SERVICE INFORMATION

Vol. 1 No. 10

LAND-ROVER PETROL AND DIESEL MODELS

December, 1972

Fig. 1 Inlet manifold butterfly valve

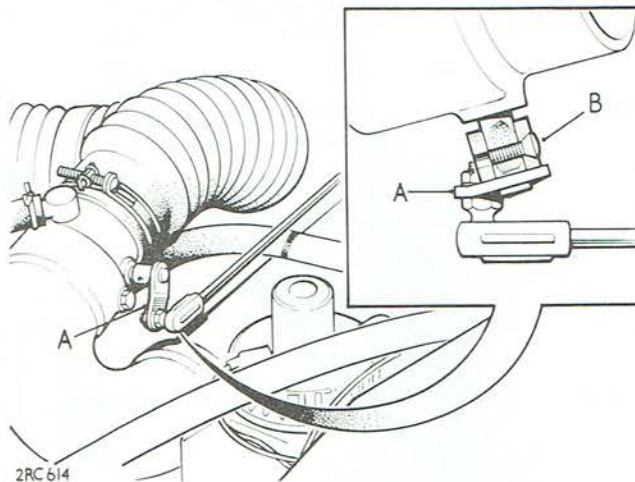
A small number of cases have been reported where the clamp screw, which locks the operating lever to the butterfly valve, has come loose.

If this condition is present on a vehicle, it can cause either a loss of vacuum or excessive smoke to be emitted from the exhaust. Should Distributor or Dealer personnel come across this problem they are advised to first check the positioning and tightness of the clamp screw. If the component is found to be loose it is recommended 'Studlock' or 'Loctite' is applied and the screw re-tightened.

Production Department, as an interim measure, from April, 1972, have been applying 'Studlock' on the screw. To overcome this possible condition permanently, however, it is anticipated that a re-design of the particular area concerned will be carried out.

Fig. 2 Distance piece for inner hub bearing

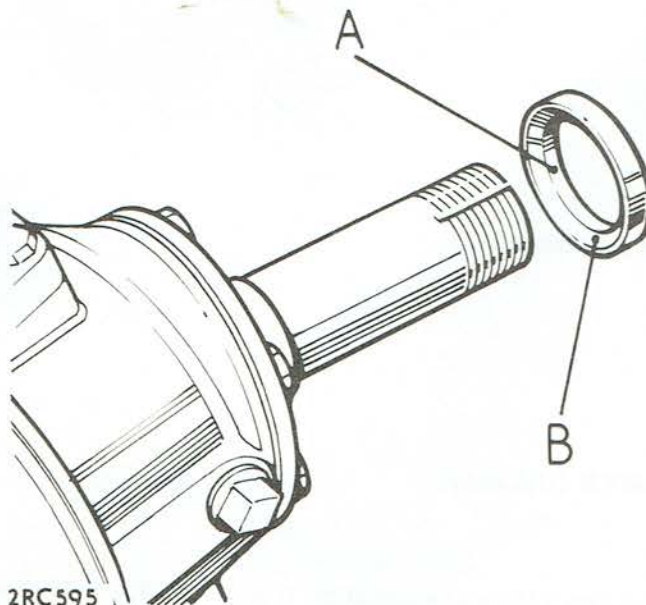
MODIFICATION: Introduction of mild steel distance piece to eliminate oil leaks arising from previous sintered iron type.

A number of Land-Rover owners have experienced hub oil leaks which, in most cases, may be attributed to the sintered iron type inner bearing distance piece, Part No. 217351. This may be subject to splitting in service and cases of porosity have been reported, believed to be due to surface cracking.

Where hub oil leaks are due to this condition the inner bearing distance piece can be removed as described in the appropriate manual operation listed above and replaced with the latest mild steel type, Part No. 599698, ensuring that Bostick 772 is applied liberally to the inner circumference and the tapered surface which faces the back plate.

NOTE: Because of the material change the mild steel distance piece cannot be removed in the same way as the sintered iron type. In this case, it is recommended that, by exercising reasonable care the distance piece can be partially cut through with a sharp chisel to loosen it, when it can be gently prised off.

Fig. 3 Windscreen pivot arm fixings

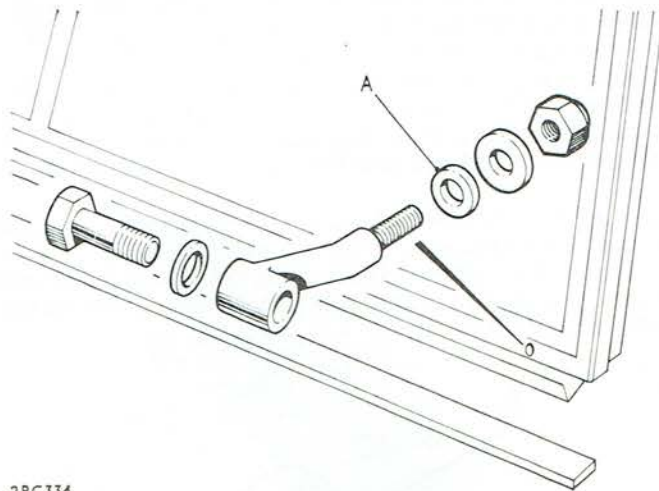
MODIFICATION: Change of washer material.

REMARKS: In certain instances the fibre washer between the windscreen and the pivot arm cracks after initial tightening and during service this washer is displaced by vibration, thereby allowing movement between the windscreen assembly and the windscreen pivot arm. The eventual consequences of this condition is a cracked or broken windscreen pivot arm. The fibre washer has now been replaced by a copper washer and this should be used for all replacements.

PART NUMBER: Copper washer for windscreen pivot 2 232038
